# Access Compliance Report

## Public Rights-of-Way

Intersection ID: 10018039	Main Street: MUNSING_DR	Cross Street: N/A	Location: N
ADA ID: 8BB591634E30	Ramp Type: Perp	Initial Pass/Fail: Fail	Overall Compliance: No
		Severity Score: 10

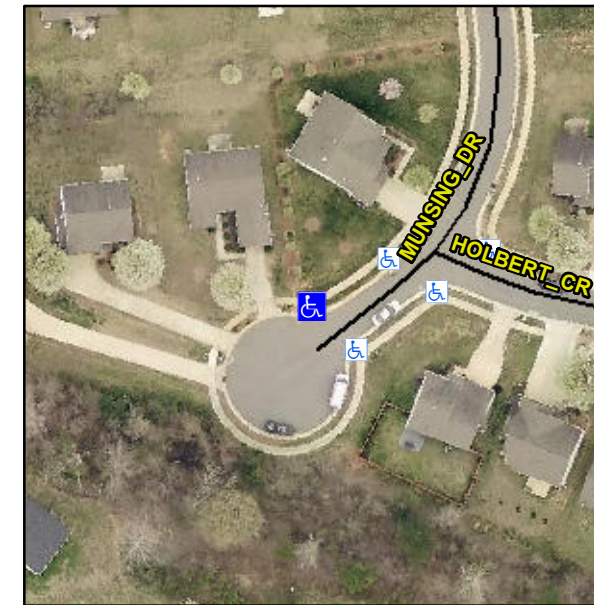
**Not Found, R304.5.1, R304.5.3**

Compliance	Description	Data	Compliance	Description	Data
N/A	Ramp Length (in)	48.0	Yes	Ramp Slope (%)	5.1
No	Ramp Width (in)	41.0	No	Ramp XSlope (%)	3.8
N/A	Flare Type LT	N/A	N/A	Flare Type RT	N/A
N/A	Flare Slope LT (%)	N/A	N/A	Flare Slope RT (%)	N/A
N/A	Flare Traversable LT?	N/A	N/A	Flare Traversable RT?	N/A
N/A	Landing Length (in)	N/A	N/A	DWS Provided?	N/A
N/A	Landing Width (in)	N/A	N/A	DWS Contrast?	N/A
N/A	Landing Slope (%)	N/A	N/A	DWS Length (in)	N/A
N/A	Landing X Slope (%)	N/A	N/A	DWS Full Width?	N/A
N/A	Landing Curb? (Y/N)	N/A	N/A	DWS Offset (in)	N/A
N/A	Shared Landing?	N/A			
N/A	Gutter Ponding?	N/A	N/A	Gutter Slope (%)	N/A
N/A	Gutter Lip Ht (in)	N/A	N/A	Gutter X Slope (%)	N/A
N/A	Painted X Walk1?	No	N/A	Painted X Walk2?	N/A
	X Walk 1 Direction	To S		X Walk 2 Direction	N/A
N/A	X Walk 1 Width (in)	N/A	N/A	X Walk 2 Width (in)	N/A
	X Walk 1 Slope (%)	6.0		X Walk 2 Slope (%)	N/A
	X Walk 1 X Slope (%)	0.7		X Walk 2 X Slope (%)	N/A

**Remove & Replace Entire Ramp.**
